Pentavia, Mill Hill

Planning Addendum
May 2019

GLA COMMENTS SUMMARY

Comment 1.3 - Updated Overall Plan (Level 03) with revised units

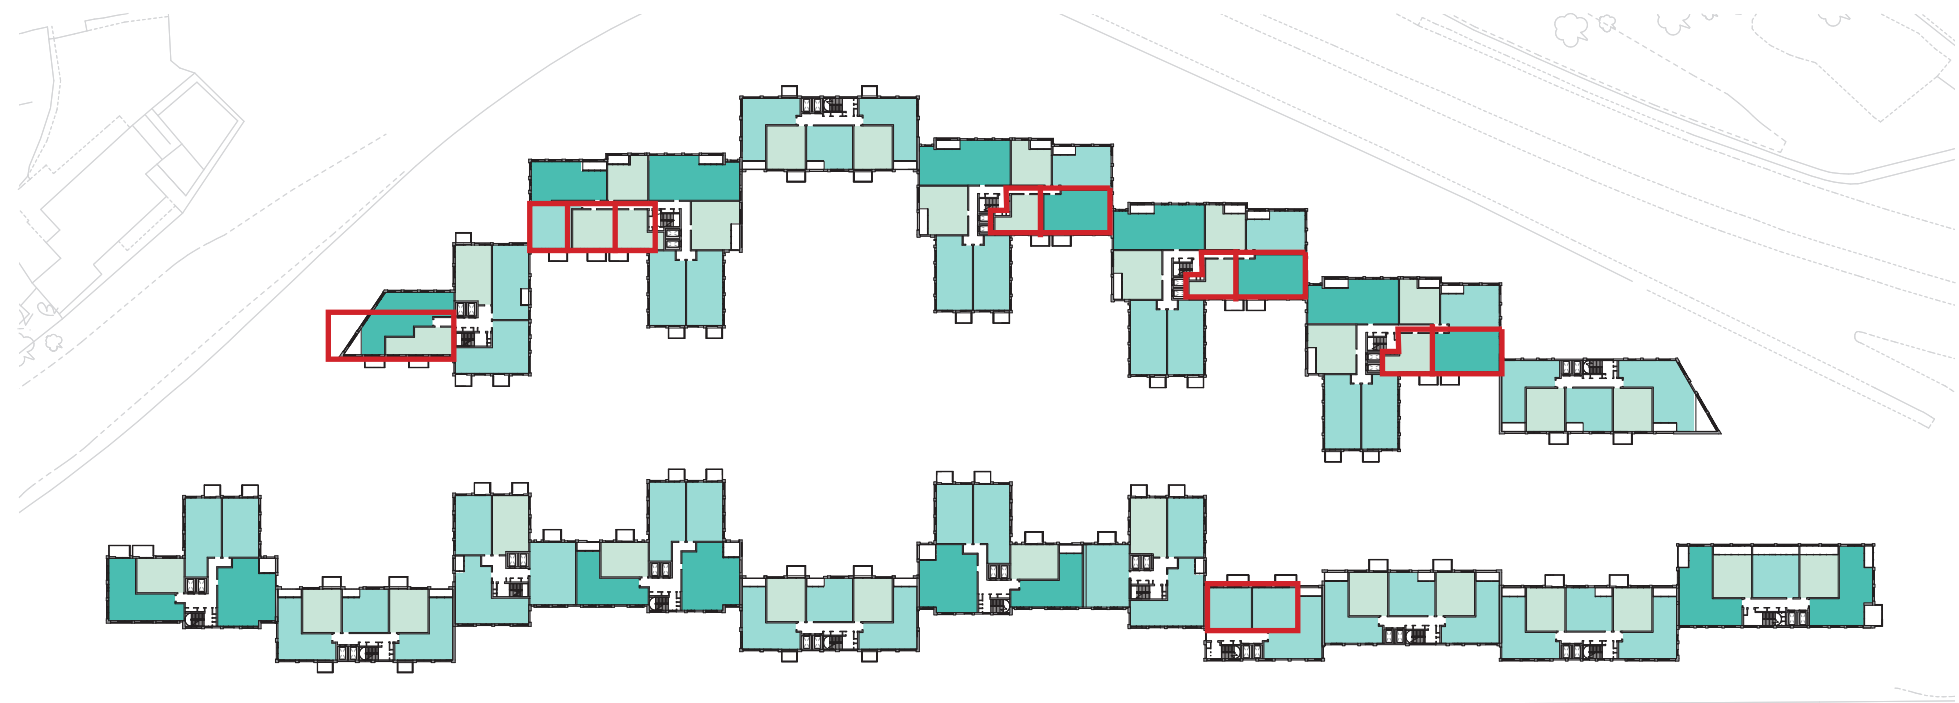
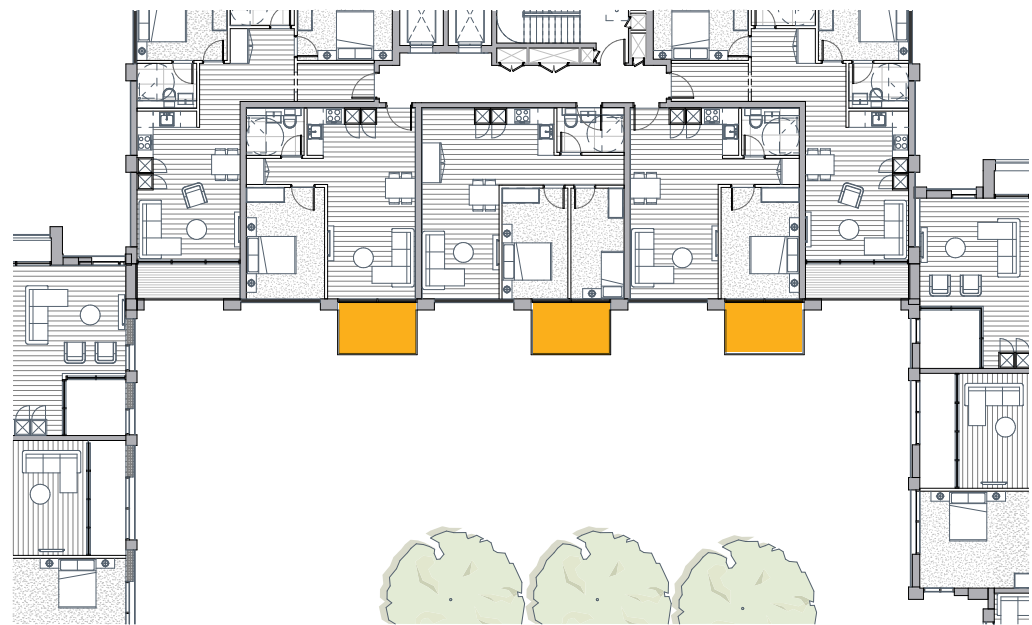
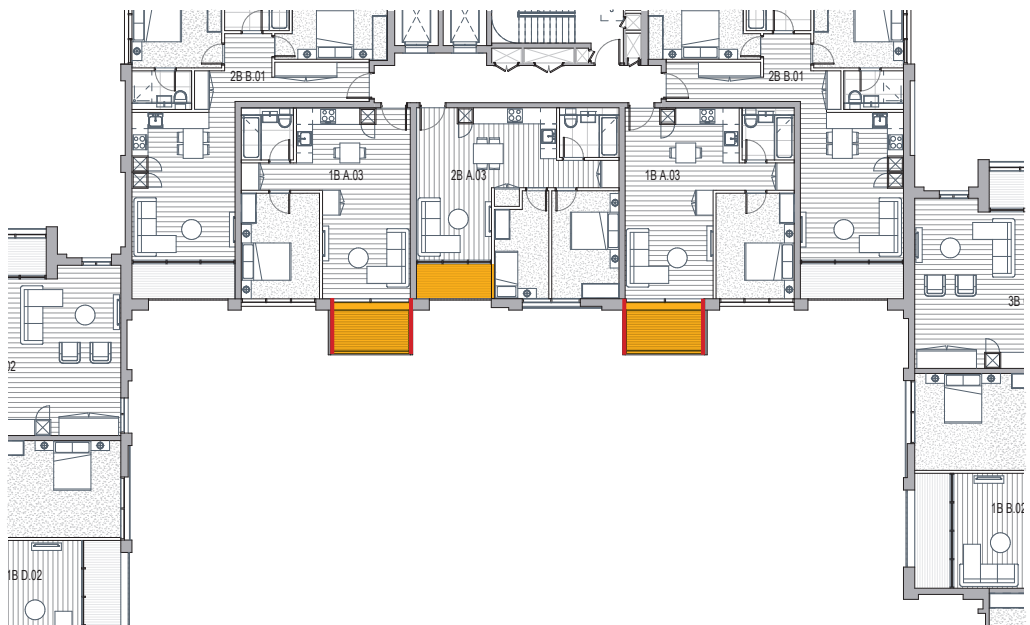
- Upper floors – there are a number of instances highlighted on the annotated plans where the placement of balconies would lead to overlooking issues between units facing each other across the corners of courtyards. This is sometimes caused by some of the units having multiple balconies (which is not necessary), or where the placement of balconies means they serve bedrooms rather than living rooms and are consequently closer to the living room on adjacent facing block. This could be addressed by either removing multiple balconies serving units; or by moving the balcony inwards into the centre of the courtyard as illustrated in the annotated plans. This would also have the benefit of ensuring the balconies would serve living rooms, rather than bedrooms.

- Recessed balconies added in some living spaces to eliminate overlooking between different units
- Balconies / winter gardens serving living spaces
- Solid sides have been added for privacy

- Revised balconies configuration
- 1.8m opaque side provided

Comment 1.4 - Updated Overall Plan (Level 03) with revised units

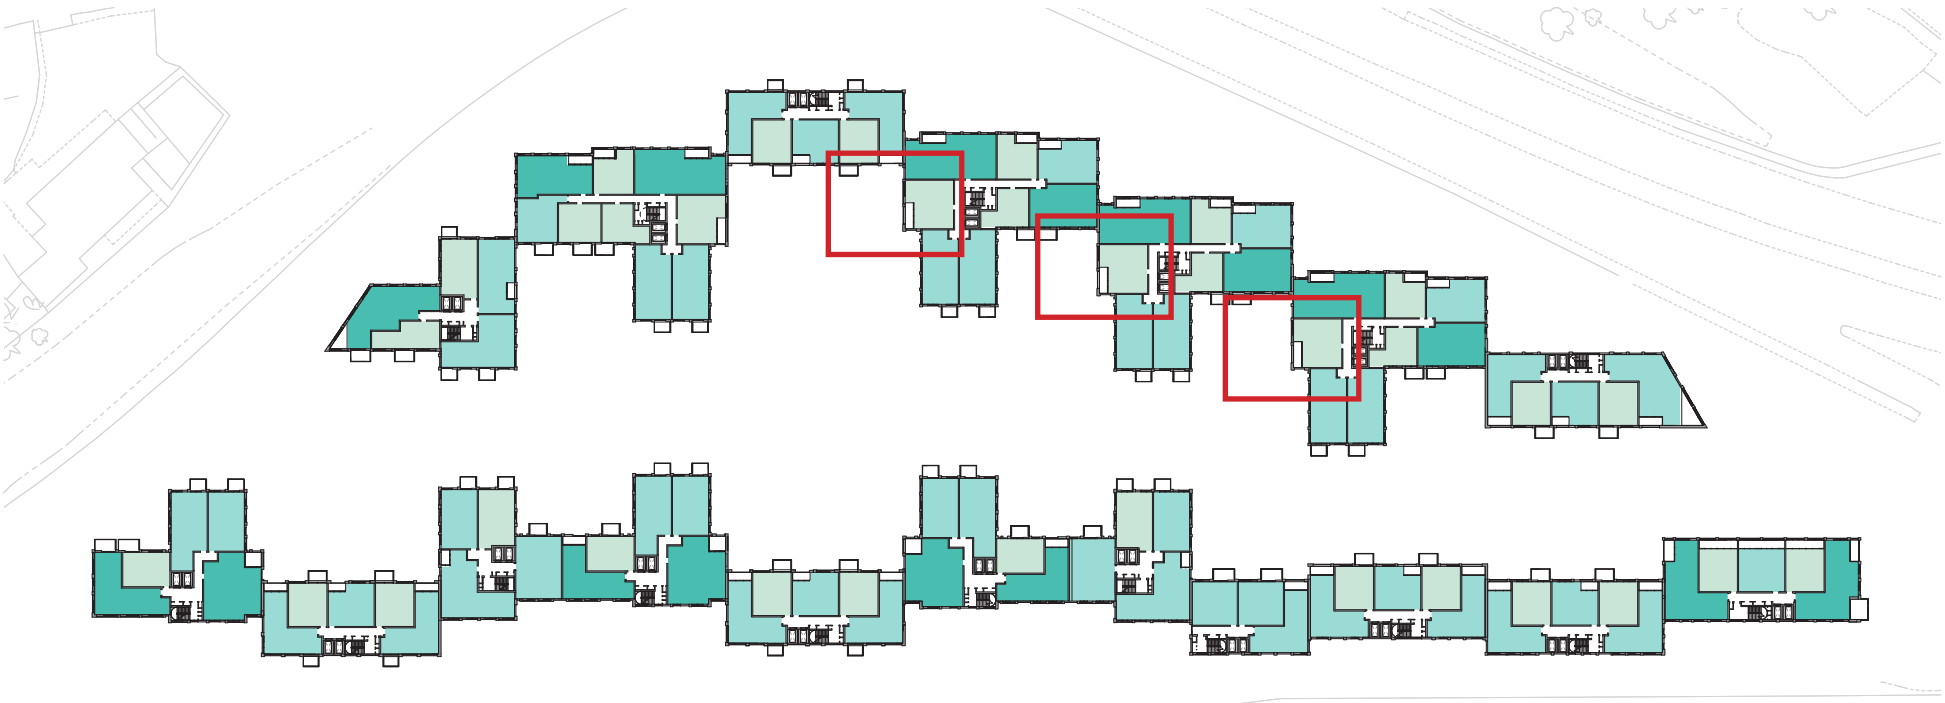
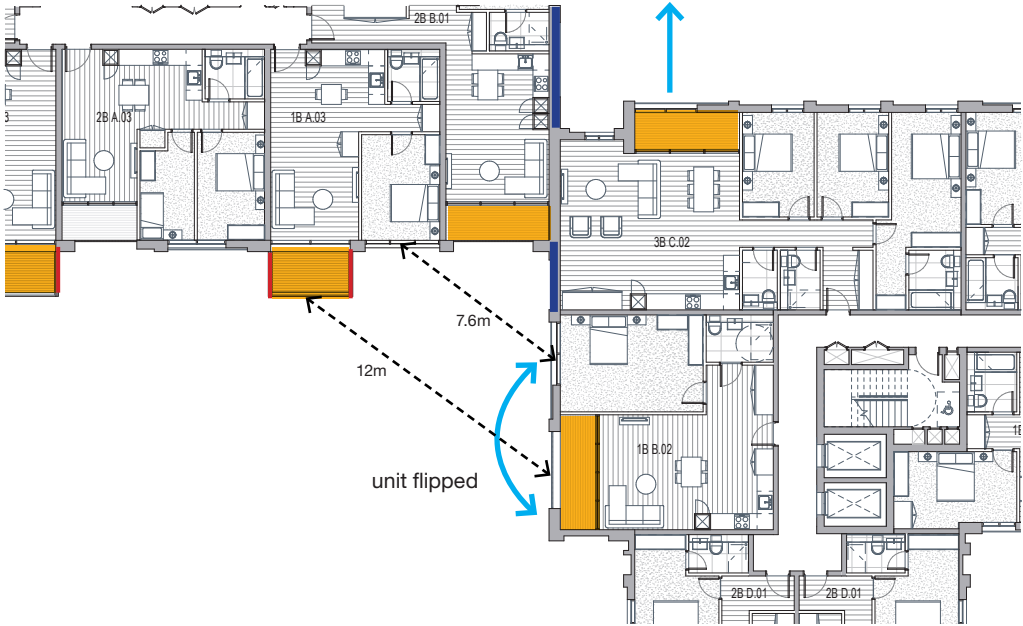
- For example - see the units in Blocks K and H in the corner of the courtyard. There are currently 4 balconies serving 4 separate units which give rise to overlooking issues. There are some examples of overlooking and privacy provided in the D&A statement in response to the MDAs comments, but this example is not provided. It would be improved by moving balcony as shown in attached annotated plans.

- To address this specific area – solid sides have been added to wintergarden sides to Block K. On Block H to reduce number of units overlooking the courtyard, one of the units are facing to the A1. One 1 Bed unit is flipped so the balcony space is positioned away from the corner.

- Revised balconies configuration
- Solid facade
- 1.8m opaque side provided

Comment 1.5 - Updated Overall Plan (Level06) with revised balconies configuration

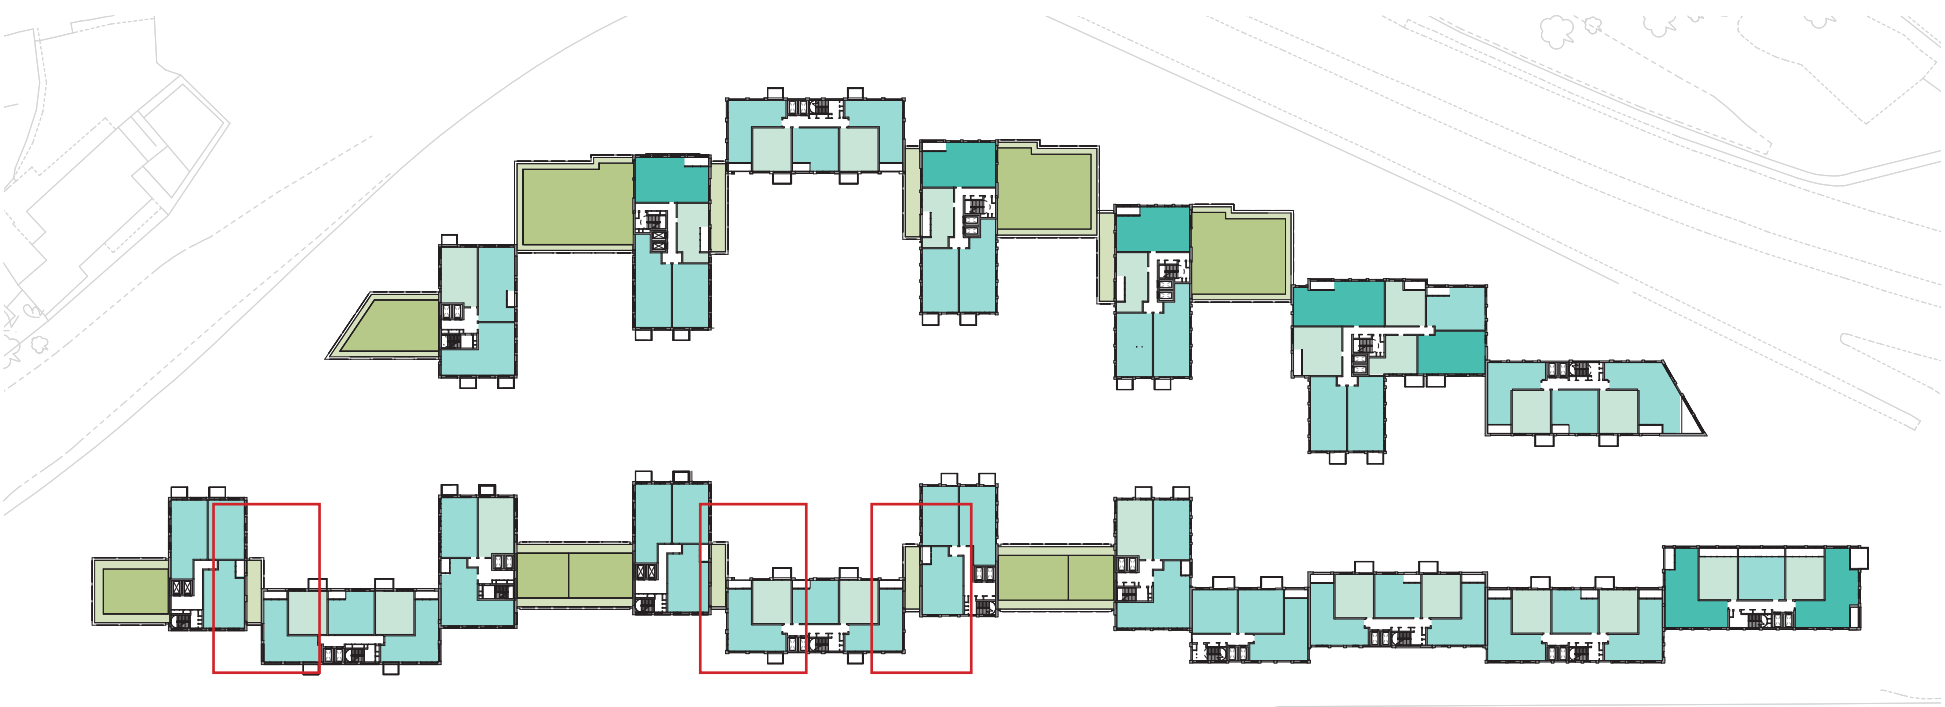
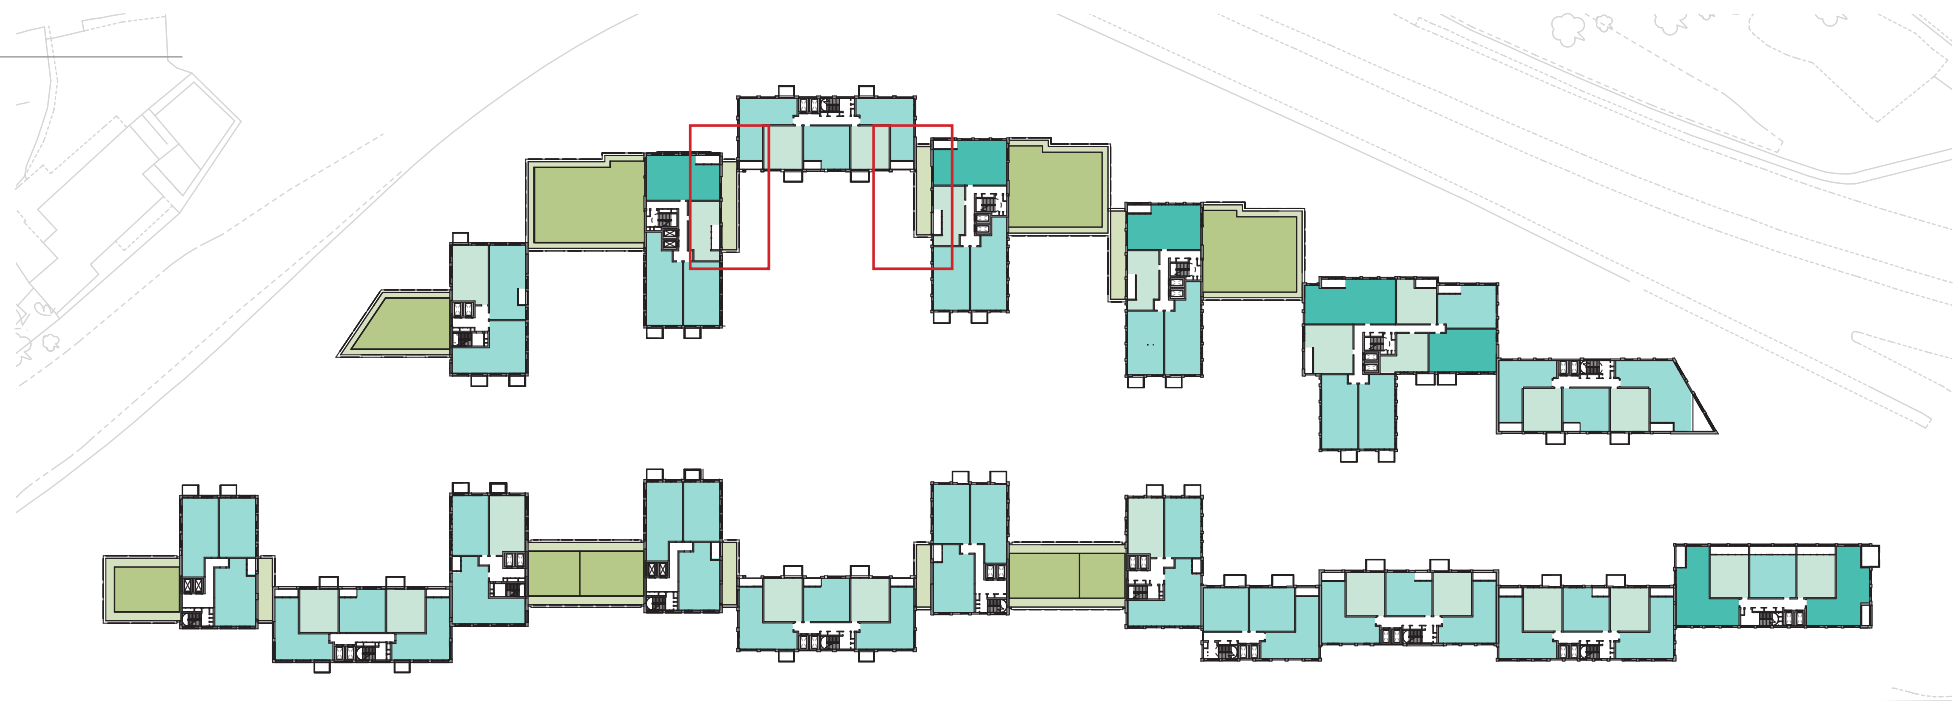
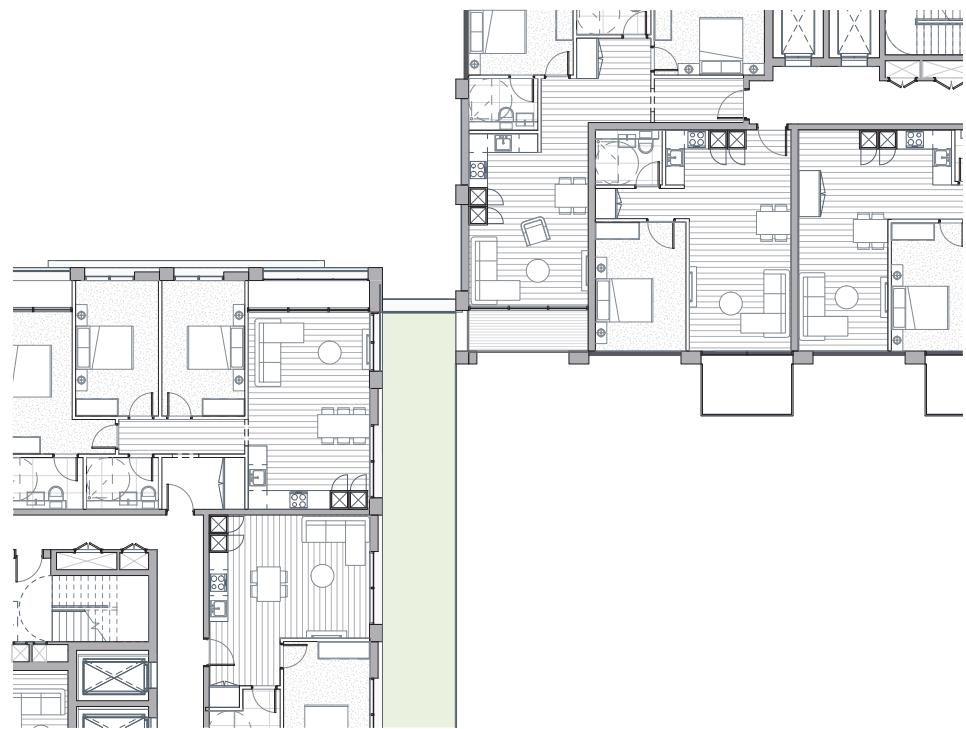
- The following interfaces raise privacy / overlooking issues and are not shown or examined as part of your privacy assessment on page 42 of the Design and Access Statement, responding to the MDA's comments
- The separation distances need to be confirmed and privacy / overlooking issues fully addressed/mitigated – it appears to be below 5 metres
- Currently, the relationship is not acceptable and this would need to be addressed and fully mitigated in terms of potential overlooking and privacy.

- Blocks N and L (Levels 05 to 07): we have reconfigured and solved the overlooking issues
- Blocks J and L (Levels 05 to 09): we have reconfigured and solved the overlooking issues

Comment 1.5 - Updated Unit Layout
Revised balconies configuration
Solid facade
1.8m opaque side provided

Comment 2.1 - Typical floor plan Level 03 (Planning application drawings - March 2019)

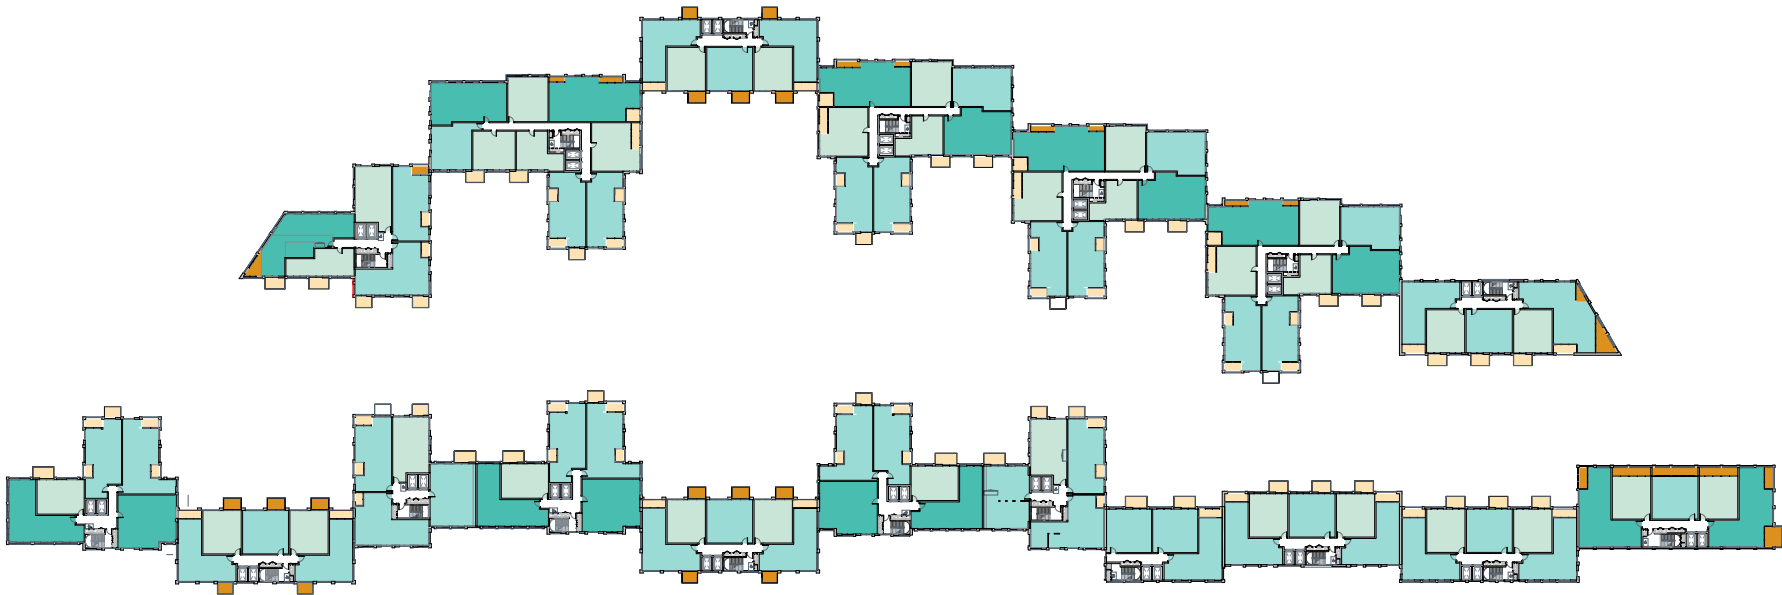
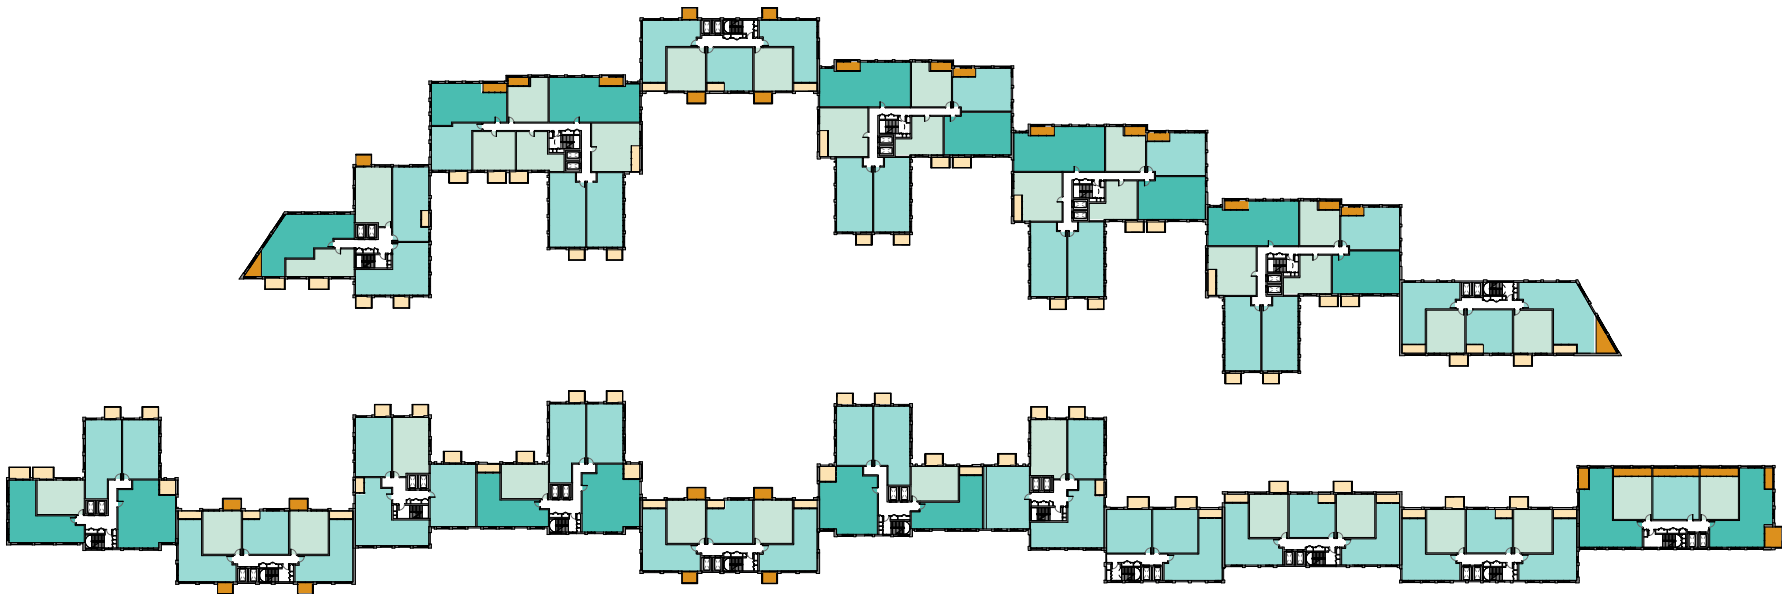
- Various units on level 01 and 02 facing internal courtyard

- Previously the reason for not having balconies on this level was due to the Daylight accessibility. We have now added winter gardens on level 01 and Level 02 balconies so all units have private amenity space.
